MARICOPA COUNTY
Department of Transportation

MEMORANDUM

Subject: Revision to Section 405 MONUMENTS [and Detail 120](#)

Case 14-02

DETAIL NO.
120

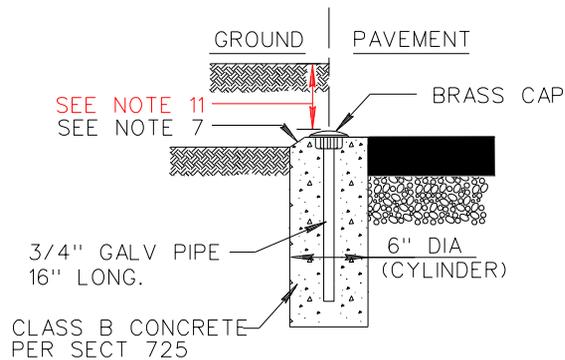
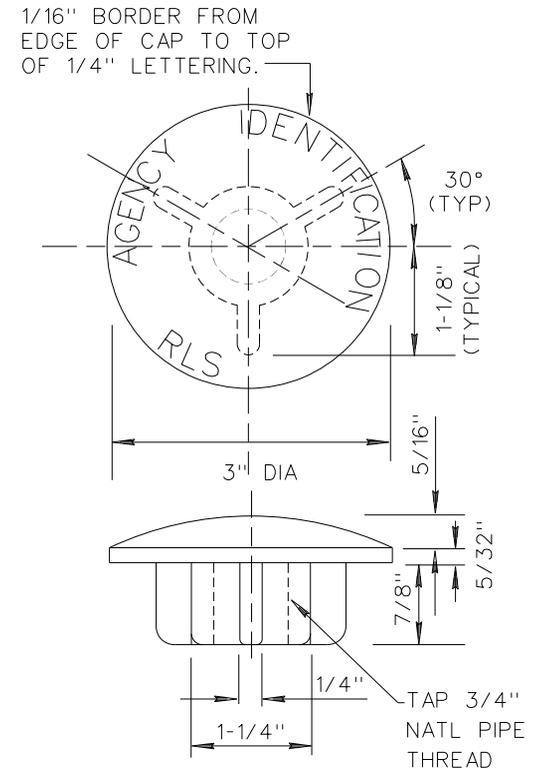
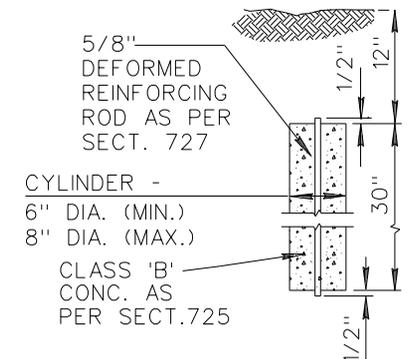
[Add note to Type B Monument in Detail 120 to have the depth recessed six inches below finished grade when located in an unpaved roadway or alley.](#)

11. FOR UNPAVED STREETS AND ALLEYS SET TOP OF MARKER SIX INCHES BELOW FINISHED GRADE
